MATERIALS RECYCLING FACILITY 600 WOODSTOCK AVENUE, ROOTY HILL

Response to Submissions - SSDA-29999239

Prepared for
CHARTER HALL
10 August 2022

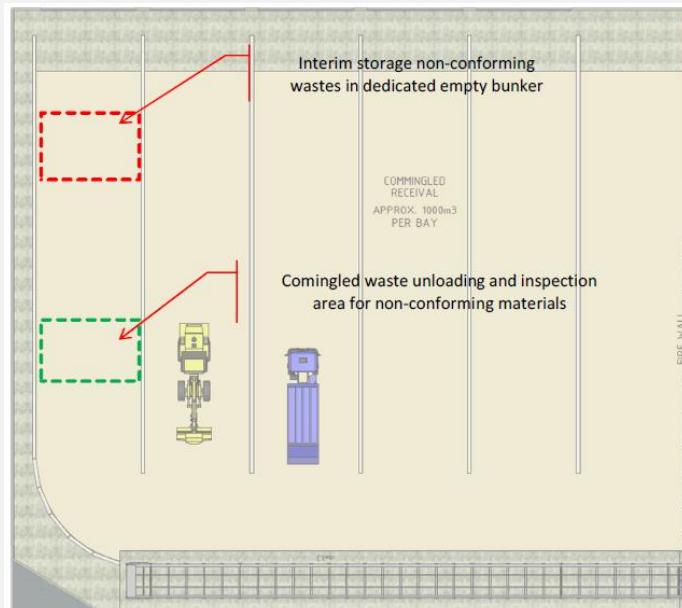
6	<p>Section 5.2.3.3 of the WMP advises that 'incoming materials will be inspected in the five bays in the main receival hall. Loads suspected to contain hazardous material will be isolated to a single receival bay until they can be inspected and photographed'. Please clarify if the single receival bay is one of the six commingled receival bays. If so, please clarify:</p> <p>(a) what measures are proposed in the event that all receival bays are occupied</p> <p>(b) what measures are proposed to ensure hazardous materials would not contaminate other wastes unloaded in the same bay.</p>	<p>Cleanaway (the future operator) will prepare a detailed Waste Management Operational Plan during the detailed design phase. The Applicant accepts a condition of consent for a detailed Waste Management Operational Plan to be prepared prior to the issue of a CC.</p>	N/A
7	<p>Section 5.2.3.3 of the WMP advises that 'inbound commercial cardboard loads will be deposited at the commercial OCC receival area, well away from other cardboard, so the load can be inspected for contamination or signs of a hot load, prior to being pushed onto the baler feed conveyor. Cleanaway's policies for hot loads and contaminated loads will be followed if an incident occurs'.</p> <p>Please clarify and detail the policies for hot loads and contaminated loads.</p>	<p>Section 5.2.3.3 of the updated WMP has been revised to provide greater detail in response to the issues raised by DPE:</p> <ul style="list-style-type: none"> ▪ If waste is identified that is not allowed on site (eg putrescible waste), the loader driver will immediately contact the weighbridge operator. If possible, the weighbridge operator will stop the vehicle that deposited the load and inform the driver that the load dropped is a material that is not accepted on the site. If the vehicle has already left the site, the vehicle's details will have been recorded in the weighbridge software. ▪ In either case, the weighbridge operator will notify the Operations Manager that the incident has occurred, the Operations Supervisor will then contact the customer. The details of the incident are entered into MyOSH and written notification provided to the customer. The loader driver will segregate any loads not accepted by the site and place 	Appendix F

them in the quarantine area. Waste in the quarantine area will be disposed of appropriately within one week.

Figure 4 from the updated WMP below shows the waste receipt and storage locations for non-conforming material. The interim storage location for non-conforming wastes may be located in any of the receivals bay and will only be stored in empty bays.

Location of the co-mingled waste bunkers

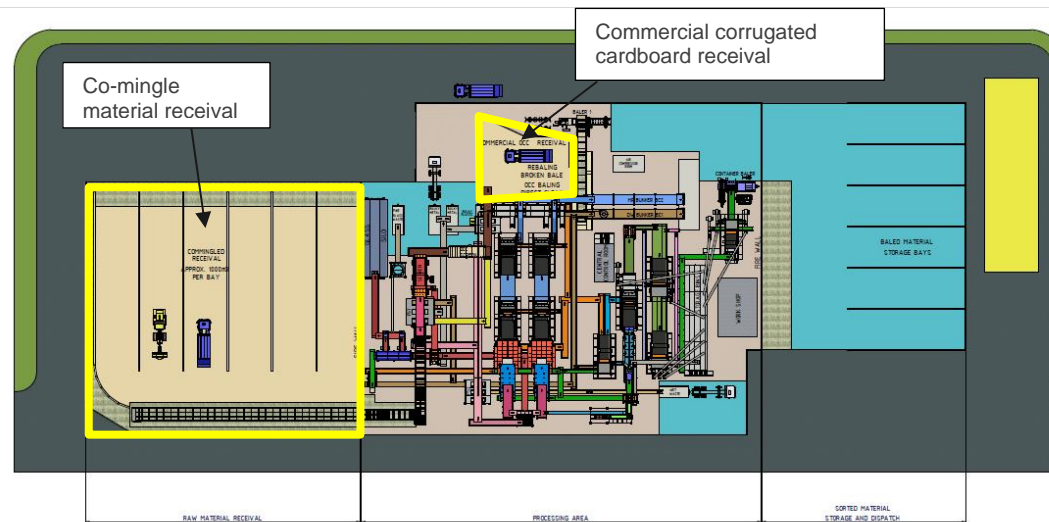
8 Section 5.2.2 of the WMP states that ‘the contents of the vehicles will be discharged into one of five bunkers on the southern side of the facility. A grab arm will remove any hazardous or undesirable items before a wheeled loader pushes the stockpiles onto a

Refer to Row 5 of Table 5 and Appendix A of the updated WMP, which contains the below site plan. The location of the co-mingled receival bunkers, comprising five bunkers for mixed recyclables and one for a glass silo is located on the left of the plan. This is where the grab arm and conveyor belt is located to feed into the sorting area. Waste will be emptied into the bunkers directly from the trucks, which will reverse into the bunkers.

Movement of co-mingled waste to bunkers

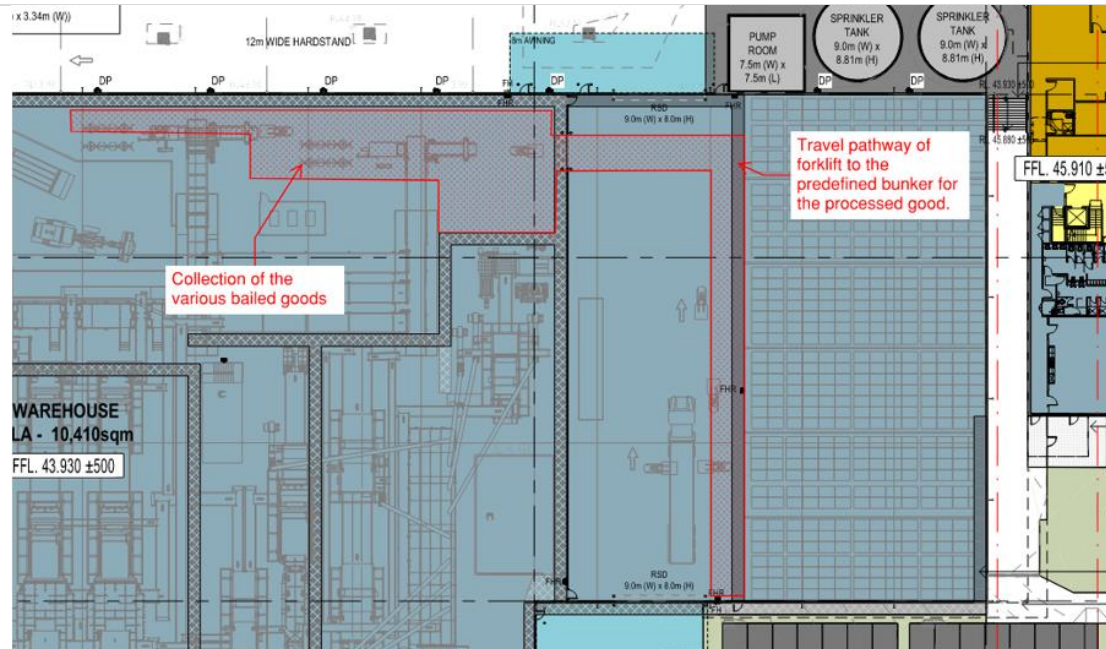
conveyor that leads into the sorting and processing facility'. Please clarify:

The area highlighted in the below figure shows where the baled materials will be collected and moved to the storage area via forklift trucks. The figure shows clear paths for separation between trucks and forklifts. The storage bays are designed to be multipurpose and will be managed by the operations team to identify what particular sorted materials will be stored in each bay and bunker.

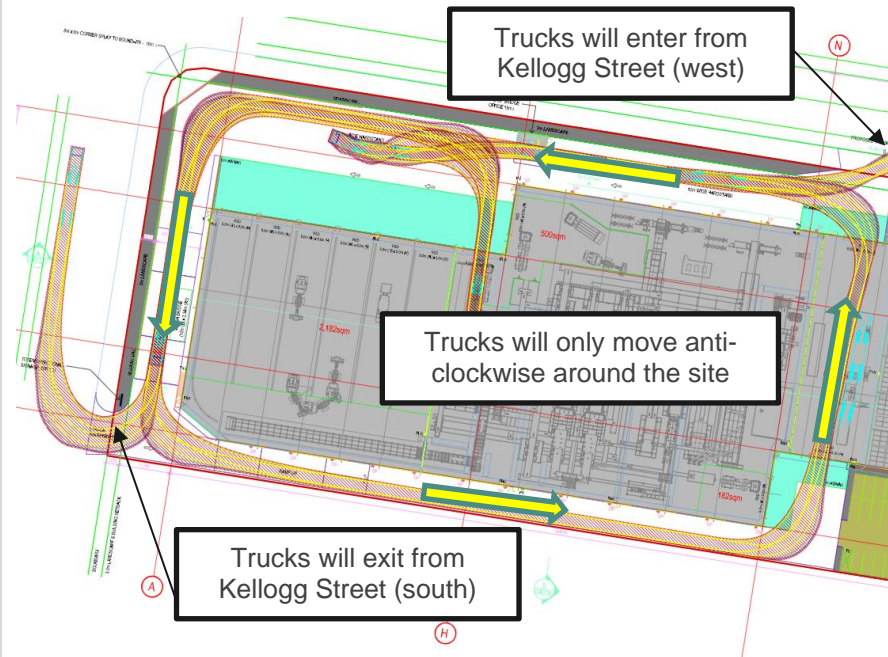
18	<p>The Department notes it appears the swept path diagrams in the Traffic Impact Assessment show the internal driveway to the east of the processing building would carry two-way traffic, whereas the architectural plan shows the driveway is used for northbound trucks only. Should the driveway carry two-way traffic, it appears there would be movement conflicts between various types of trucks.</p> <p>Please clarify by providing updated swept path diagrams.</p>	<p>The site is designed to operate with vehicles moving in a one-way traffic environment clockwise around the site (aside from vehicles reversing into bays).</p> <p>Appendix E of the revised Traffic Impact Assessment contains updated swept path diagrams. Two main scenarios are extracted and annotated as follows.</p>	Appendix C

<p>The typical two scenarios for trucks entering the site will be:</p> <ul style="list-style-type: none"> ▪ Waste collection trucks will enter the site via Kellogg Road (west) access driveway, move to the western weighbridge, unload in the co-mingle receival area or the commercial cardboard receival area (shown in Row 8), will then move to the southern weighbridge and exit the site via Kellogg Road (south) access driveway. ▪ Dispatch articulated trucks will enter the site via Kellogg Road (west) access driveway, move to the southern weighbridge, circle around the back of the site in a clockwise motion and enter the dispatch and loading area breezeway and will load the baled materials. Loaded trucks will then leave the breezeway and turn south within the site and move to the southern weighbridge again, before leaving the site via Kellogg Road (south) access driveway. ▪ There are other low frequency vehicle movements where trucks will undertake the same entry to the site as above, however, will reverse into loading bays for collecting wet waste on the eastern boundary. These trucks will pass through the loading area breezeway and circle the site, before exiting via Kellogg Road (south) access driveway. On this occasion, this will be coordinated so that there is no loading occurring within the breezeway. There may on very rare occasions be a requirement for vehicles to move in a clockwise direction around the site if there are broken down vehicles or broken equipment. However, this will be managed carefully through operational management procedures, supported by the proposed Traffic Management System that is controlled by the weighbridge operators. <p>Traffic Management System</p> <p>An automated traffic management system will be used on the site. The system will be designed in detail prior to issue of a construction certificate for the fit out of the facility. Typically, traffic lights, sensors and line marking will manage traffic on site along with CCTV monitoring by the weighbridge office worker. Having an automated system controlled by the weighbridge office worker will minimise the likelihood of vehicle and pedestrian conflict as vehicles will not be permitted to move around the site without instruction. There will be</p>

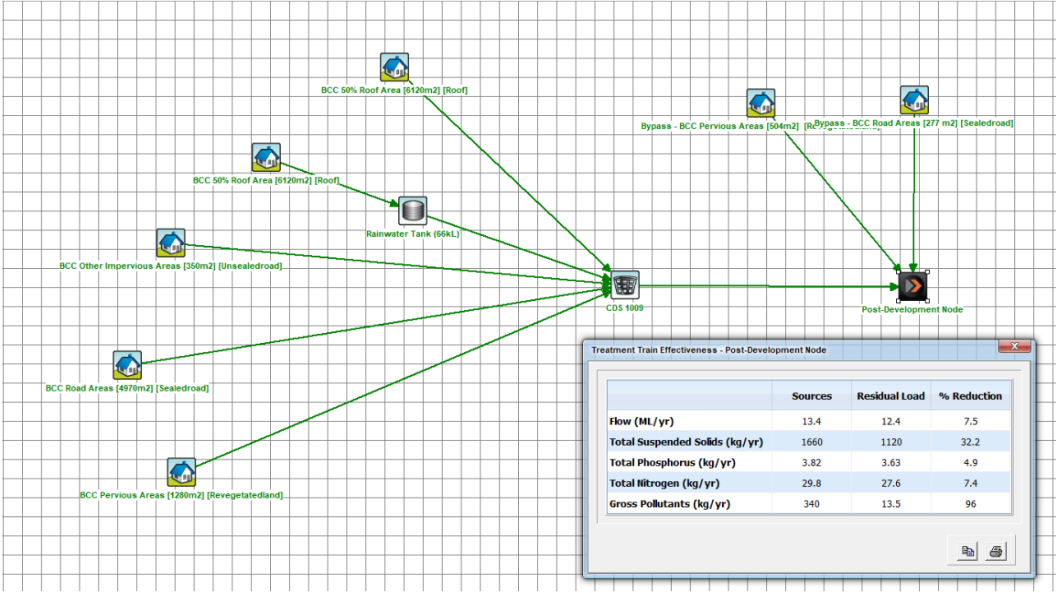
<p>25 TfNSW has requested a Green Travel Plan (GTP) by prepared for the site prior to site occupation. Within the GTP TfNSW asks that a parking management strategy be incorporated with a reduction in the amount of car spaces for the site.</p>	<p>The Applicant acknowledges TfNSW's request for a GTP, including recommendations in relation to parking management, carpooling, bicycle parking/ EoT facilities, shuttle buses and TAGs.</p> <p>The Applicant accepts a condition of consent for a GTP to be prepared prior to the issue of a CC, requiring relevant strategies to be incorporated into the project to provide alternative transport options.</p> <p>In response to TfNSW's request for further information on parking management of the tandem car parking spaces, the Traffic Impact Assessment report has been updated (refer to section 8.7 of Appendix C).</p> <p>In Section 8.7 of Appendix C, it specifies that the 40 at-grade parking spaces off Woodstock Avenue for staff and visitors is proposed to include 28 tandem parking spaces to be utilised by staff only. The details of the AM and PM parking arrangements are extracted as follows.</p>	<p>Appendix C</p>

<div data-bbox="790 201 1350 866"> </div> <div data-bbox="1406 209 1877 866"> <p>AM Shift Parking Arrangement</p> <ul style="list-style-type: none"> 21 MRF spaces (85.3% of AM MRF workforce drive to work). 10 office staff spaces (85.3% of office workforce drive to work). 5 visitors spaces based on typical Cleanaway visitor demands. 4 spaces as float. <p>PM Shift Parking Arrangement</p> <ul style="list-style-type: none"> 17 MRF spaces (85.3% of PM MRF workforce drive to work). 10 office staff spaces (85.3% of office workforce drive to work). 5 visitors spaces based on typical Cleanaway visitor demands. 8 spaces as float. </div>	
26	<p>TfNSW notes that there are no bicycle parking facilities or End of Trip (EoT) facilities. They recommend that these be provided to encourage active transport use. Along with EoT and bicycle parking, a shuttle bus is recommended to take</p>	<p>The proposed parking arrangements are intended to be integrated into an operational management plan, to be prepared as a condition of consent.</p> <p>It is considered that the implementation of the parking arrangements is consistent with other parking arrangements for industrial developments and will provide the best approach for managing parking whilst providing efficient use of land, and is considered acceptable for approval.</p> <p>The Applicant acknowledges TFNSW's request for a GTP, including recommendations in relation to parking management, carpooling, bicycle parking/ End of Trip facilities, shuttle buses and Travel Access Guides (TAGs).</p> <p>The Applicant accepts and accepts a condition of consent for a GTP to be prepared prior to the issue of a CC, and will incorporate relevant strategies in consultation with the applicant.</p>	<p>Appendix C</p>

Quarantine

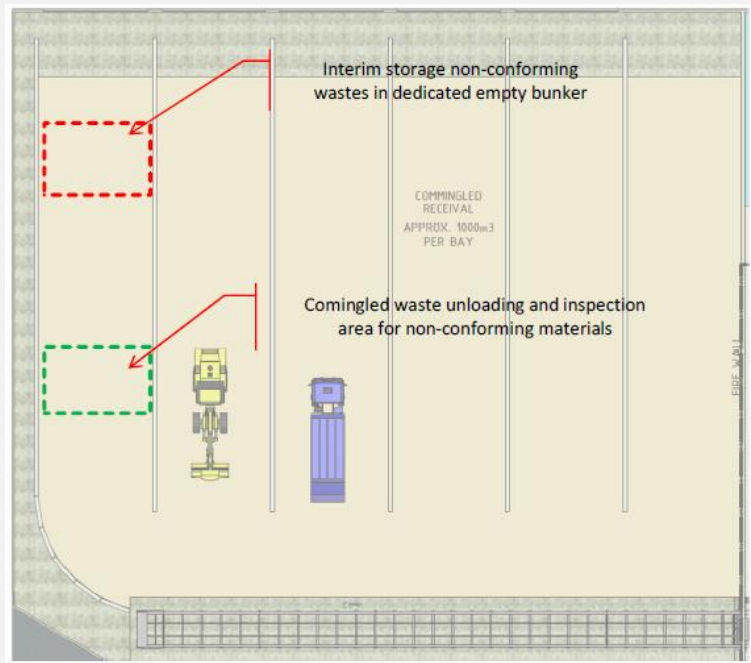
- b) The Applicant must clarify the receiving bay configuration and ensure that all documentation accurately reflects the proposed arrangement.

Additional information has been provided in Section 5.2.3.3 of the updated WMP in relation to non-conforming waste that is required to be quarantined. The below plan has been extracted from Figure 4 of the updated WMP. Non-conforming waste will be disposed of appropriately within one week.

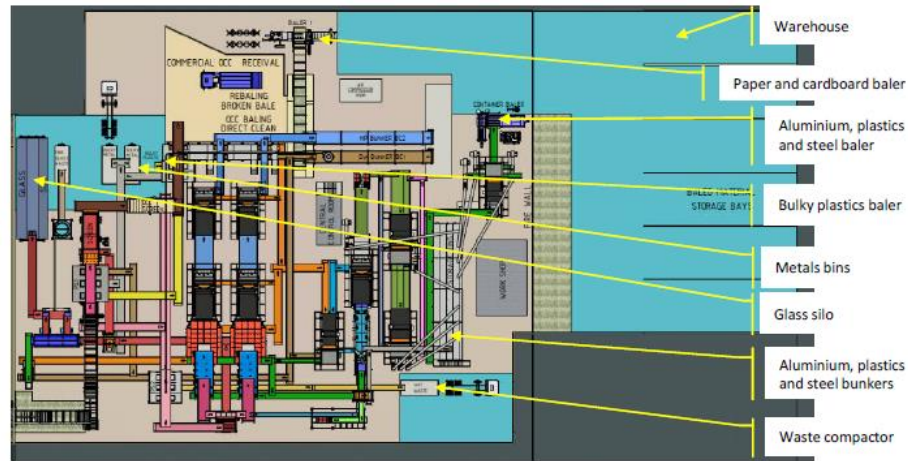
Insufficient information has also been provided in the EIS regarding contaminated and non-conforming waste, including hazardous materials, received at the premises. The EPA requires that the identification, management, storage and disposal arrangements for these materials are clarified. The EIS does not provide information to indicate that a dedicated quarantine area for the separation and storage of hazardous waste is proposed for this waste, nor that there is a process in place to ensure that all non-conforming waste is removed from the Premises as soon as practicable.

Below is an annotated plan extracted from Figure 6 of the updated WMP. It shows location of materials being dispatched for processing.
